WILLIAMSON COUNTY, TEXAS

CHANGE ORDER NUMBER: 6

**SE Loop Seg 1 Ph 1
Williamson County Project No. T3346**

Change Order No. 6

SHEET No. 383

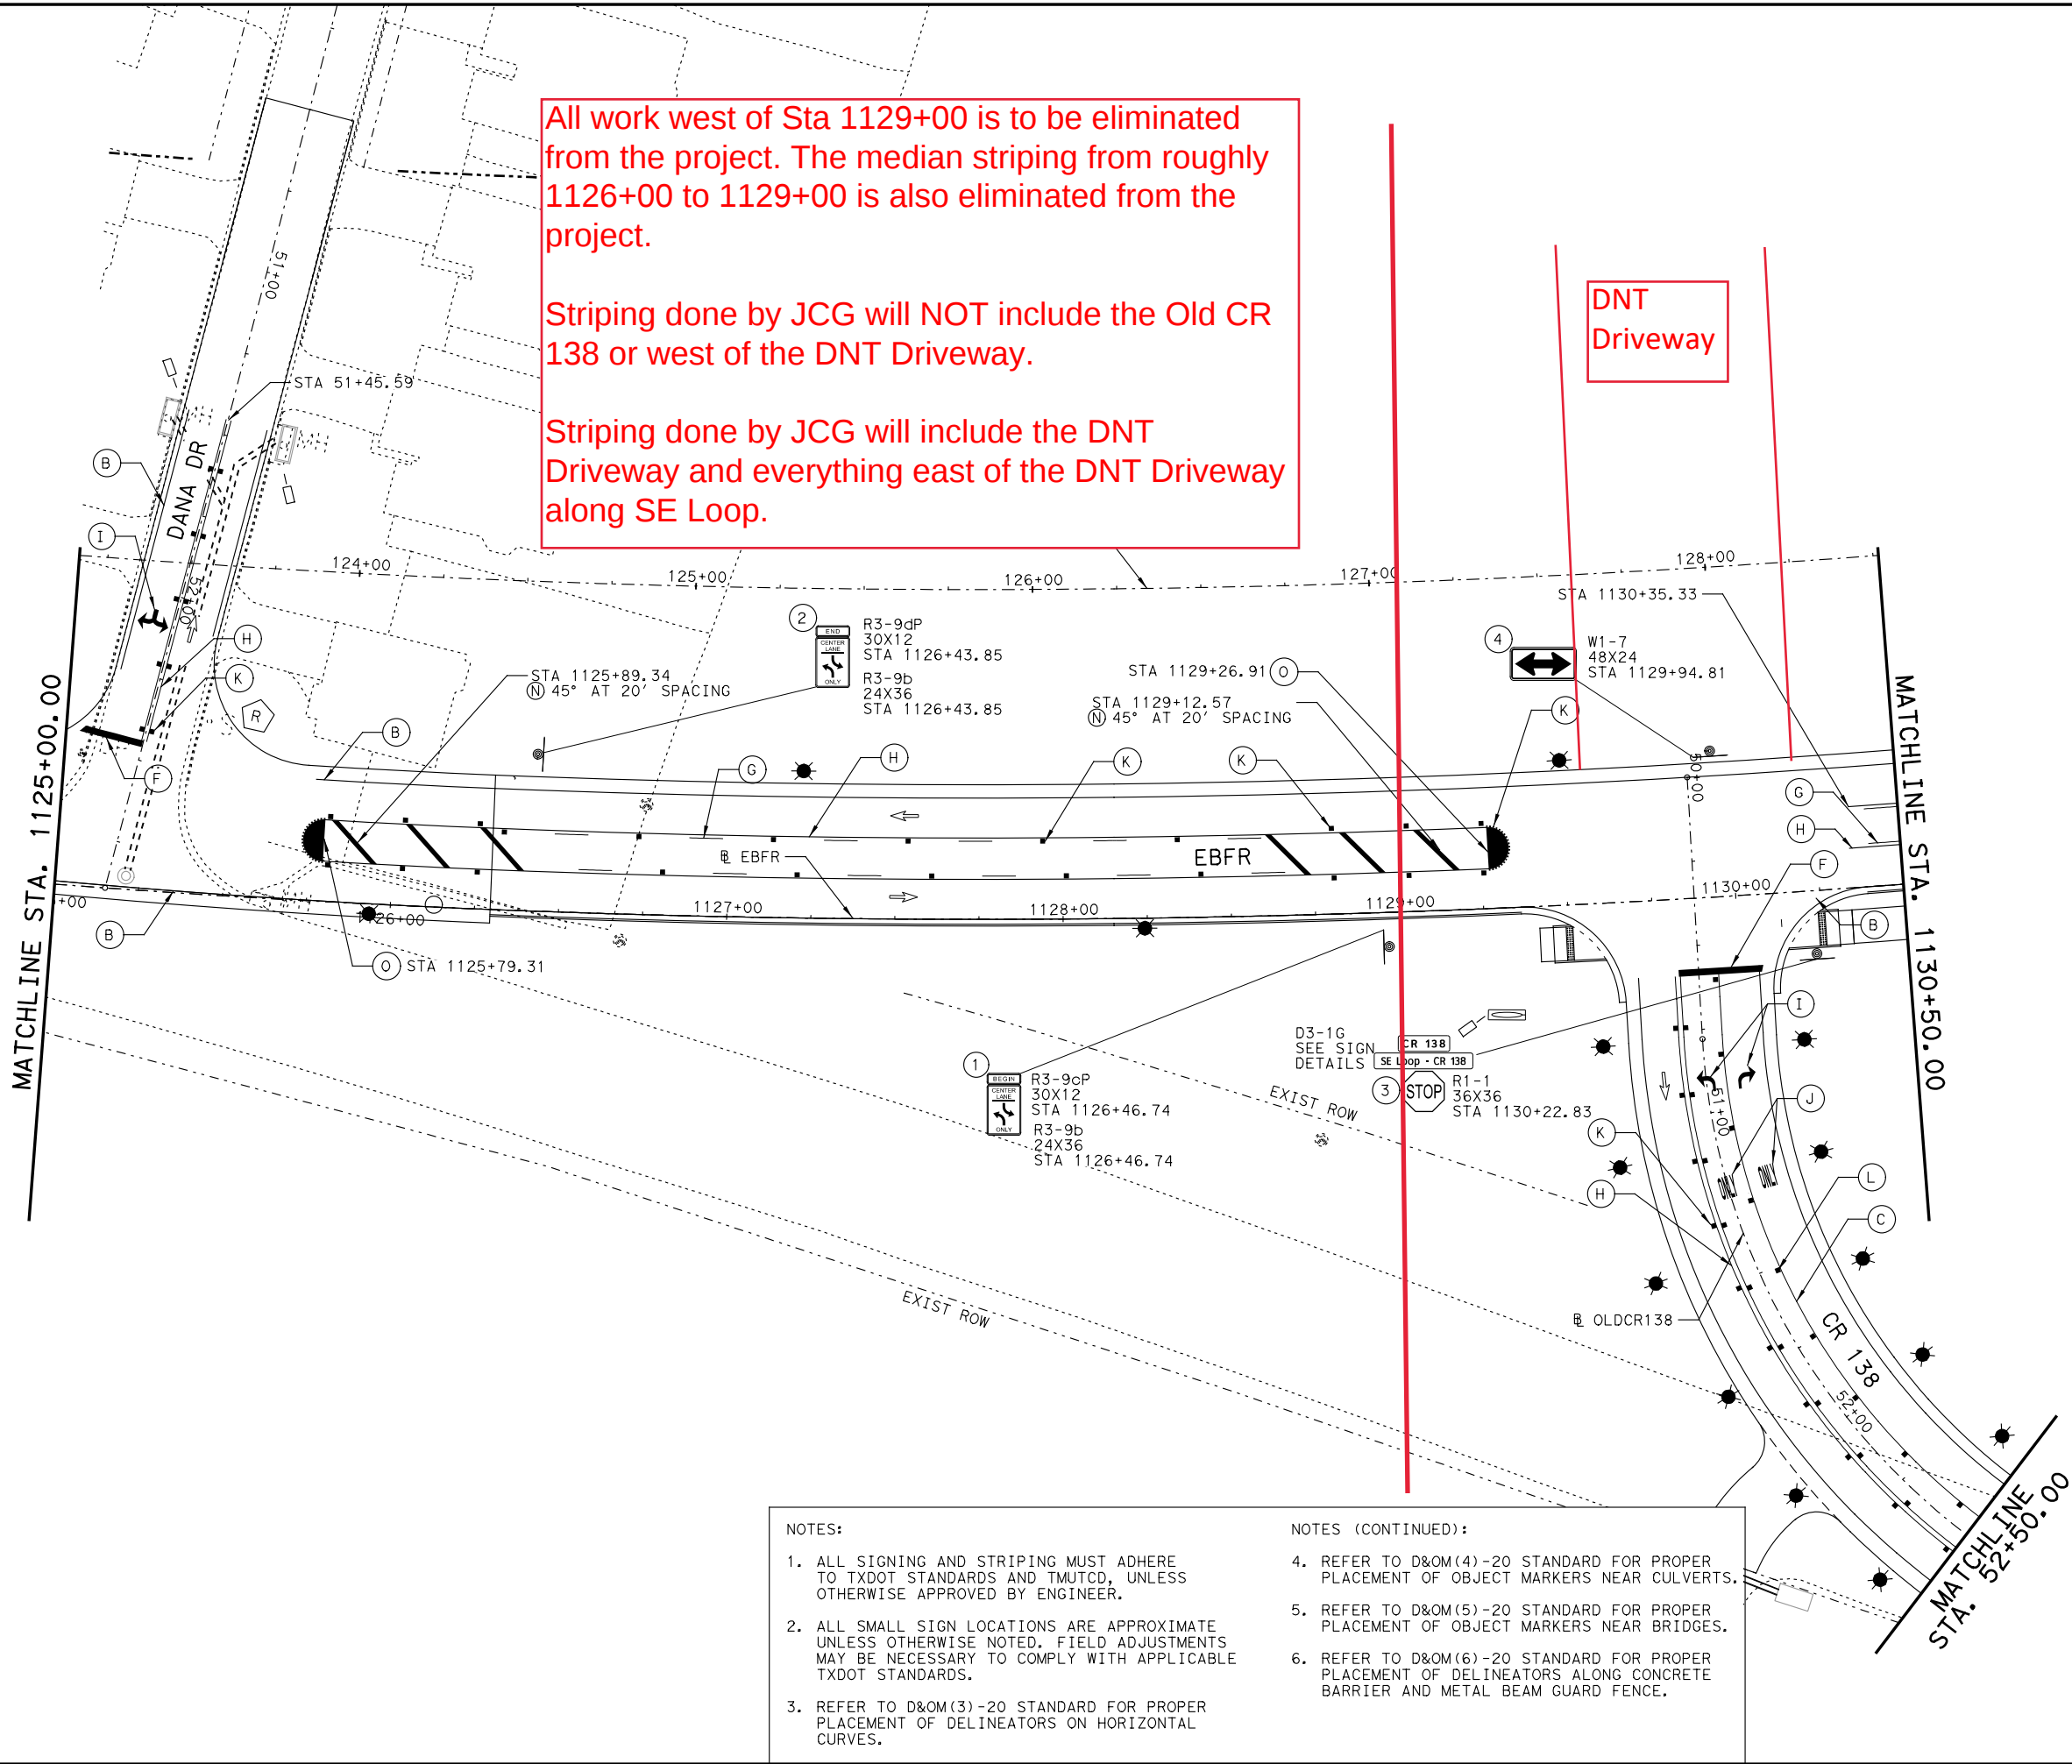
All work west of Sta 1129+00 is to be eliminated from the project. The median striping from roughly 1126+00 to 1129+00 is also eliminated from the project.

Striping done by JCG will NOT include the Old CR 138 or west of the DNT Driveway.

Striping done by JCG will include the DNT Driveway and everything east of the DNT Driveway along SE Loop.
